**CITY OF LOS ANGELES**  
INTER-DEPARTMENTAL CORRESPONDENCE

5000 Beethoven Street  
DOT Case No. CTC15-103068

Subject: **ADDENDUM TO THE TRAFFIC ASSESSMENT FOR THE PROPOSED RESIDENTIAL PROJECT  
LOCATED AT 5000 BEETHOVEN STREET**

SUBJECT: **TRAFFIC IMPACT ASSESSMENT FOR THE PROPOSED MIXED-USE RESIDENTIAL/OFFICE PROJECT TO BE LOCATED AT 5000 BEETHOVEN STREET**

**Figure 4C-3 Warrant 3**  
**Beethoven Street and Coral Tree Place**  
**AM (PM) Peak hour Traffic Signal Warrant Based on**  
**California Manual on Uniform Traffic Control Devices, 2014**  
**Future post-Project Conditions**

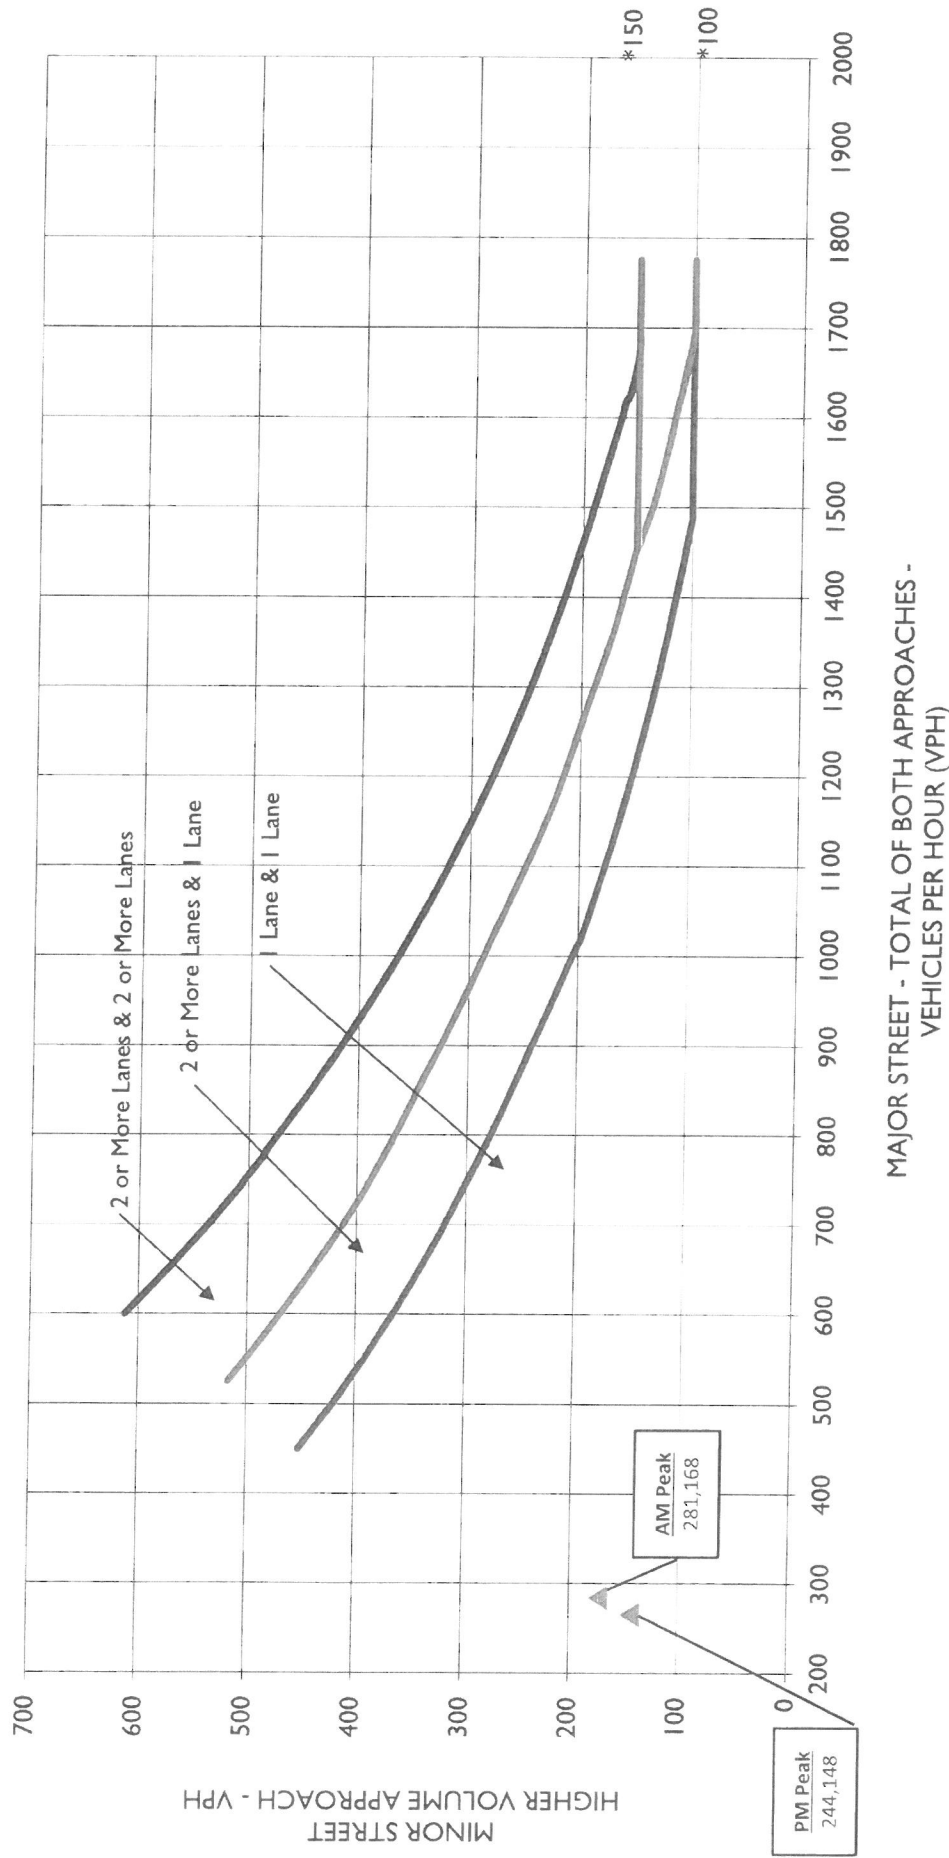
intersection to the project. Based on the minimum volume thresholds defined in the Manual of Uniform Traffic Control Devices (MUTCD), the combination of existing and forecasted project trips does not meet the minimum threshold for consideration of signalization. A copy of the study report warrant analysis (Appendix E) is provided as **Attachment "C"** to this report.
